Technical Service Bulletin

**KNOCKING NOISE FROM REAR SUSPENSION WHEN DRIVING OVER
ROAD BUMP**

Bulletin No.: 02-006/19

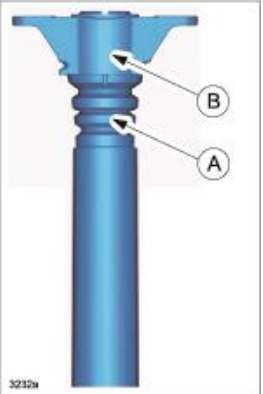
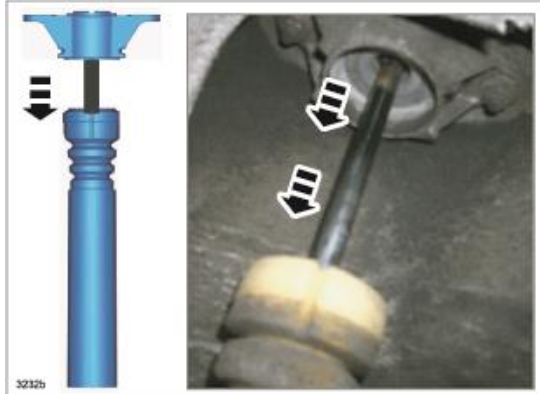
Some vehicles may exhibit a knocking noise from the rear of the vehicle when driving over a road bump. Upon inspection of the rear suspension, the bump stop (bound stopper) of the rear shock absorber is coming out of the mounting rubber.

Normal Condition: Bump stop (bound stopper) (A) is press fit and bonded to the mounting rubber (B).		Problem condition: Bump stop (bound stopper) is coming out of the mounting rubber.

This is caused by the adhesive surface of the mounting rubber bracket having inadequate roughness opposite to the bound stopper and the bracket shape being inappropriate to have sufficient holding force. The bound stopper may come out under any of the following conditions:

1. Verify customer concern.
2. Disassemble and assemble the affected rear shock absorber using a new bump stop (bound stopper) mounting rubber and nut according to the instructions on MGSS online (REAR SHOCK ABSORBER DISASSEMBLY/ASSEMBLY).

PARTS INFORMATION

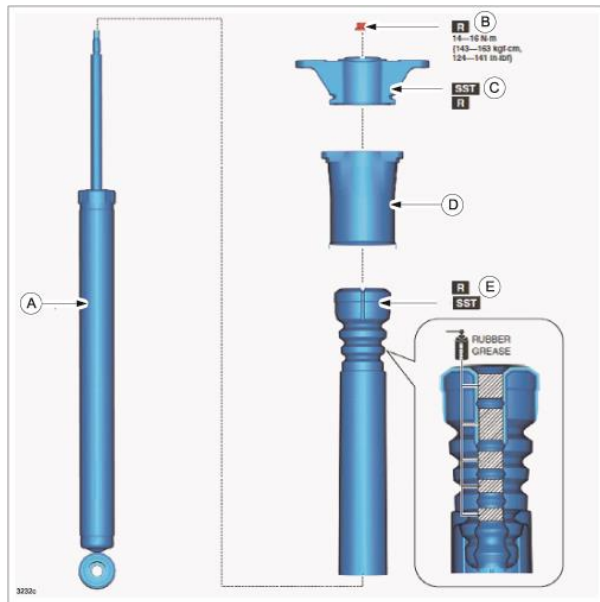
NOTE: All the parts in the chart are "Replacement Parts". There is no part number change by this mass-production change.

Part Number	Description	Qty.
B4YA-28-1A0	Bump Stop (E)	1 or 2
KDY5-28-380	Mounting Rubber (C)	1 or 2
9YB0-40-811	Nut (B)	1 or 2
